WARRANTY INFORMATION SERVICE INFORMATION

Exhaust Adaptor Plate Change On 300 Pro Max

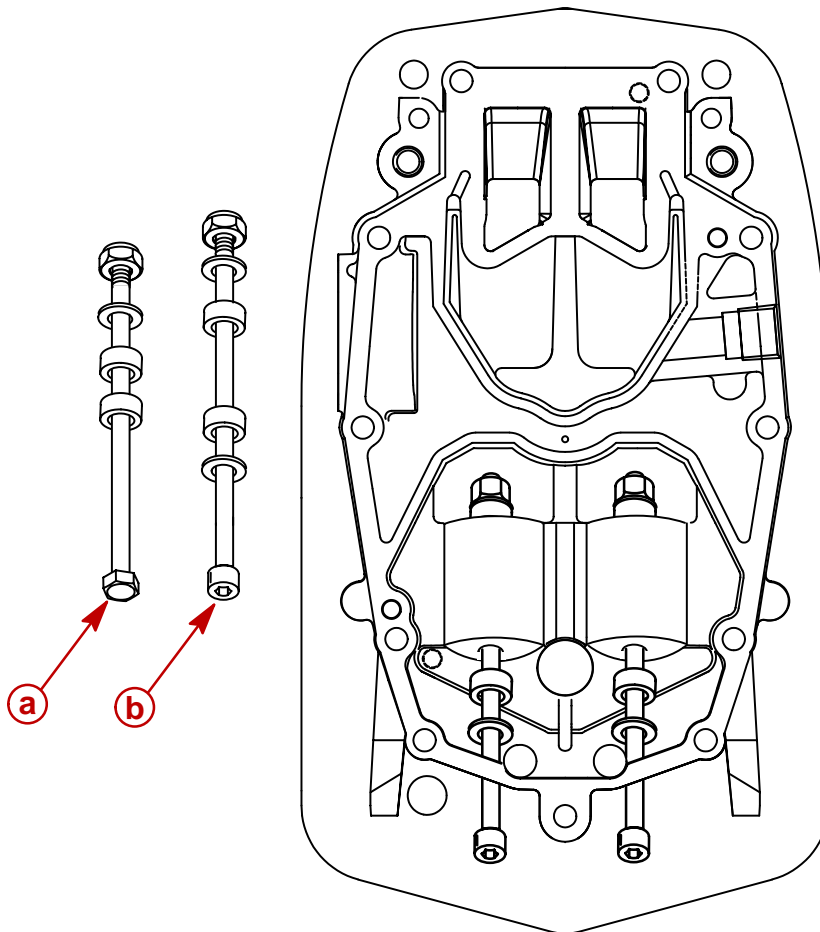
Exhaust adaptor plate P/N 840192T3 supercedes die cast plate P/N 832935A8.

Exhaust Adapter Features:

- One Piece Design
- Integrated Solid Mounts

- a** - Bolts (10-816386) Used On Standard Mid Sections - Three Ram Trim System
b - Bolts (10-849581-1) Used On Offshore Mid Sections - Single Ram Trim System
